Product Update: Drive Belt Auto-Tensioner Pivot Bolt Replacement

The repair is to replace the drive belt auto-tensioner pivot bolt and reroute the drive belt. On vehicles with A/C, a new drive belt is used in the repair. For repair, affected VIN, and warranty information, refer to Service Bulletin 09-007, *Product Update: Drive Belt Auto-Tensioner Pivot Bolt Replacement*.

WITH A/C

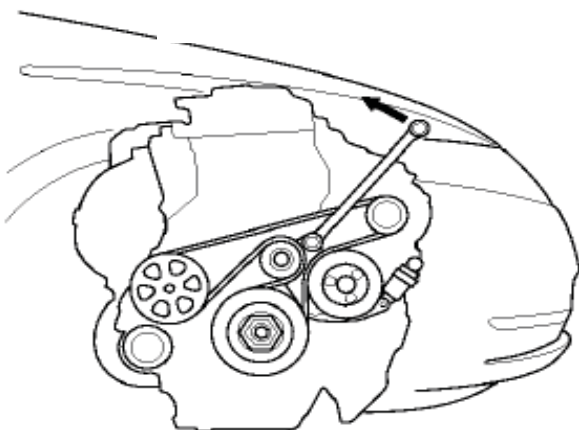
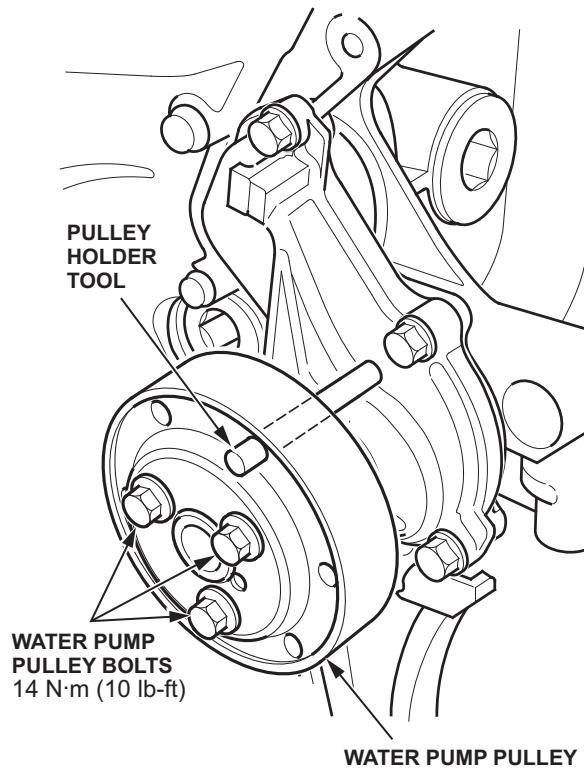
The current routing of the engine drive belt creates extra force on the drive belt auto-tensioner. In rare cases, this extra force could break the auto-tensioner pivot bolt, causing an engine noise or a loss of power steering.

Replace the auto-tensioner pivot bolt, and reroute the drive belt. On vehicles with A/C, install a new drive belt.

- On vehicles with A/C, route a new drive belt around the engine pulleys as shown below. On vehicles without A/C, route the original drive belt as shown in step 1.

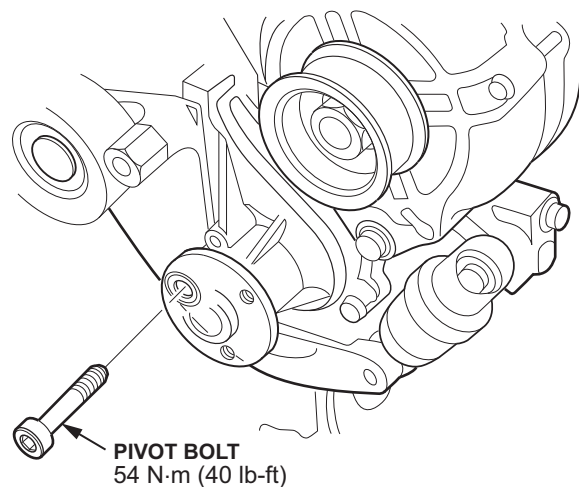
3. Remove the water pump pulley (three bolts).
4. Remove the pivot bolt from the drive belt auto-tensioner.

NOTE: In rare cases, the pivot bolt may be broken. If this has happened, remove the auto-tensioner, then remove the shank of the pivot bolt with Vise Grips or by drilling it out. *Do not try to repair the engine block using a TIME-SERT.* If you can't remove the shank of the pivot bolt, you would need DPSM approval to install an engine short block assembly.

- Install a new pivot bolt on the auto-tensioner, and torque it to **54 N·m (40 lb-ft)**.

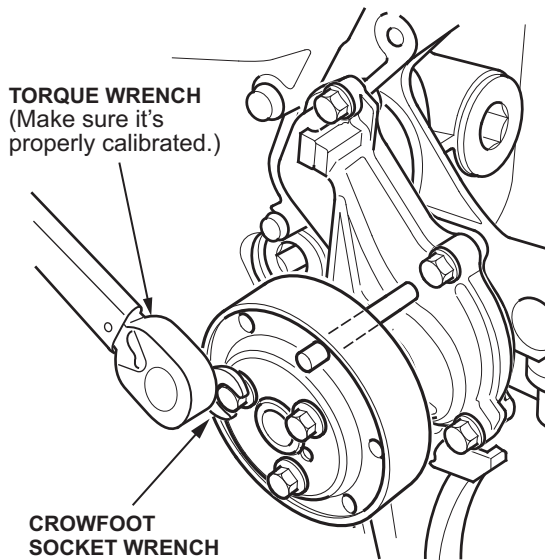
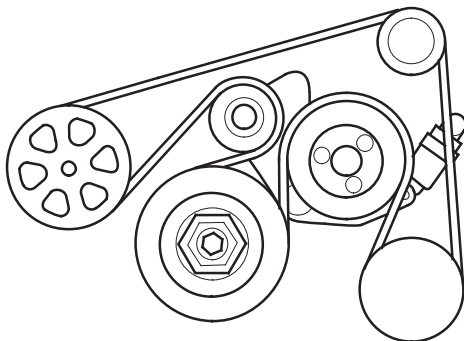
- Reinstall the water pump pulley and its three bolts. Insert the pulley holder in the 12 o'clock position to keep the pulley from moving while you torque the bolts to **14 N·m (10 lb-ft)**.

- The exact torque is critical for a successful repair.** To guarantee the correct torque, you must use an accurately calibrated torque wrench. It's OK to use a crowfoot socket wrench with the torque wrench.
- Do not install the drive belt before you torque the pulley bolts. If you do, you won't get accurate torque readings.
- Remove the pulley holder after you torque the pulley bolts.
